STATE OF CONNECTICUT
CONNECTICUT SITING COUNCIL

APPLICATION OF HOMELAND TOWERS, LLC
(HOMELAND TOWERS) AND NEW CINGULAR
WIRELESS PCS, LLC (AT&T) FOR A CERTIFICATE
OF ENVIRONMENTAL COMPATIBILITY AND
PUBLIC NEED FOR THE CONSTRUCTION,
MAINTENANCE AND OPERATION OF A
TELECOMMUNICATIONS TOWER FACILITY IN
RIDGEFIELD, CONNECTICUT

DOCKET NO. 445

**HOMELAND TOWERS, LLC and NEW CINGULAR WIRELESS, PCS LLC (AT&T)
RESPONSES TO RACT INTERROGATORIES
SET II & SUPPLEMENTAL RESPONSES TO SET I**

PROPOSED DRAINAGE PLAN

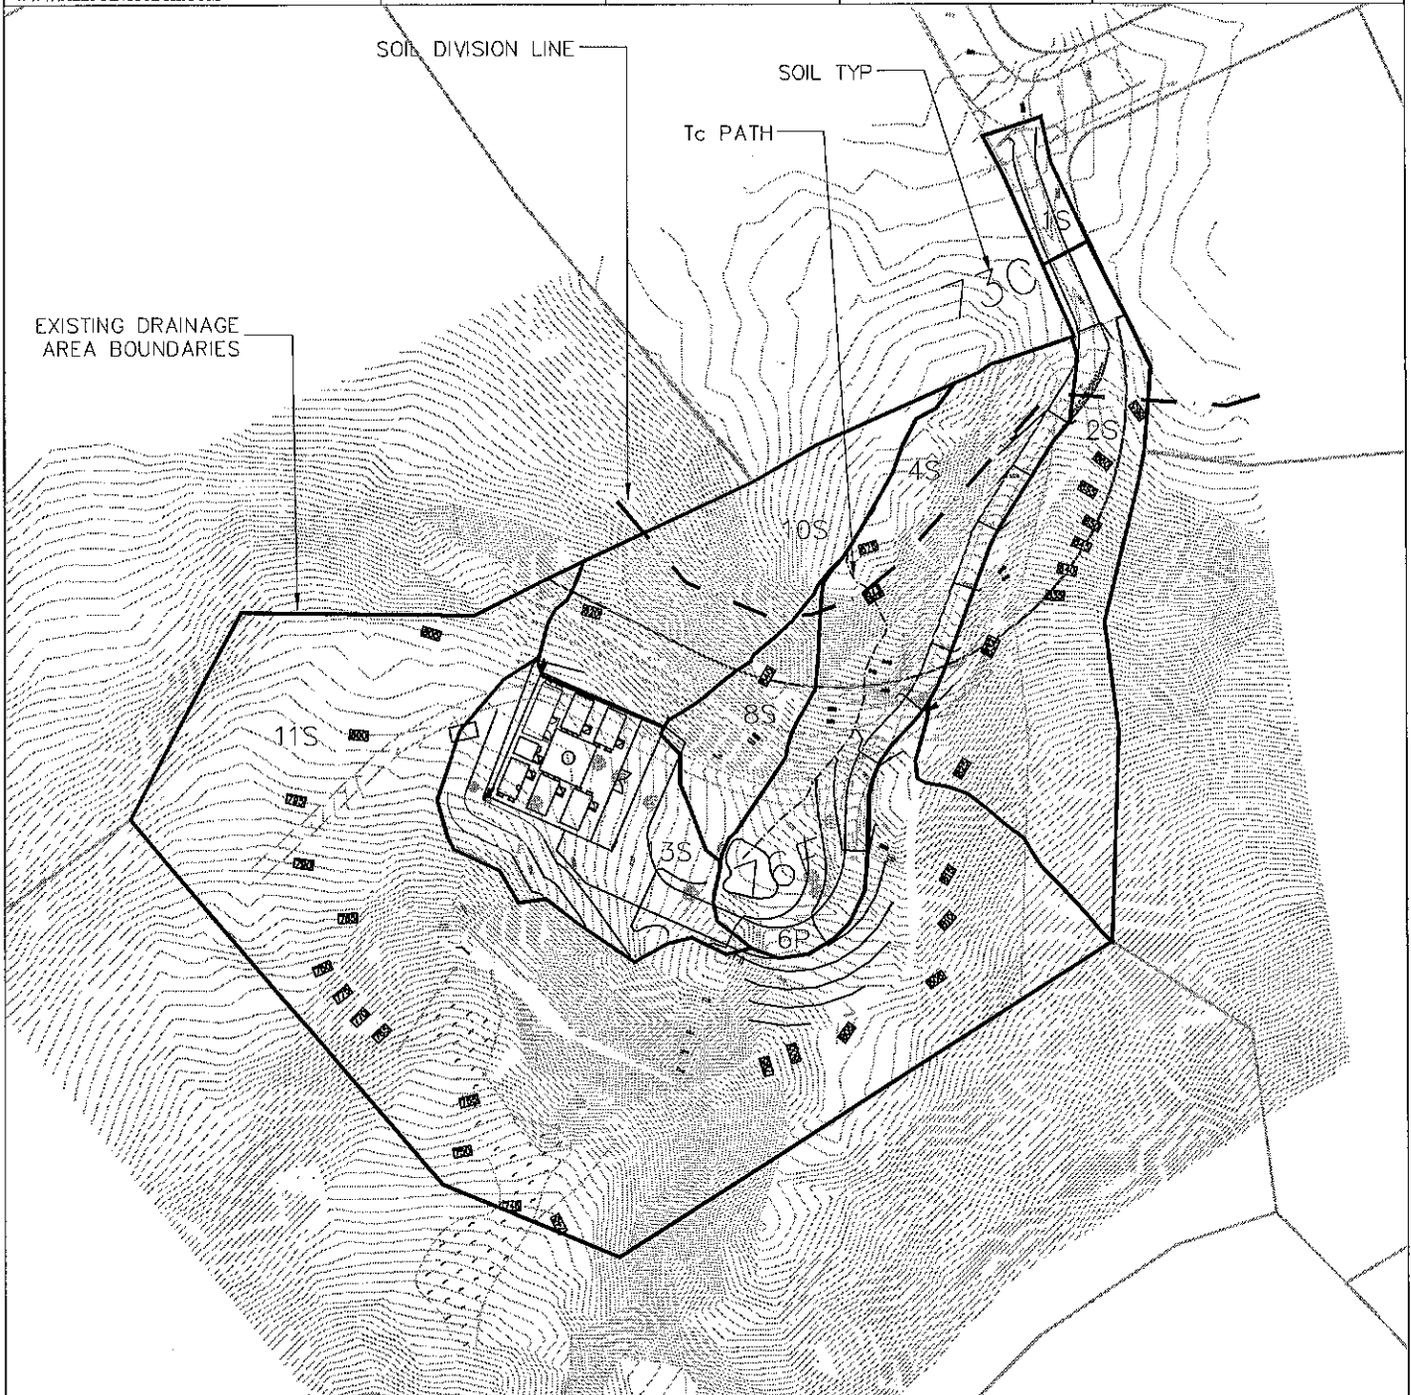
- Q4. Please provide a copy of the Proposed Drainage Plan (DR-PR) cited on p4 of the Drainage Report.
- A4. *The drainage plan is included in the "Site Drainage Report" bulk filed with the Application and another copy of drawing DR-PR is attached.*
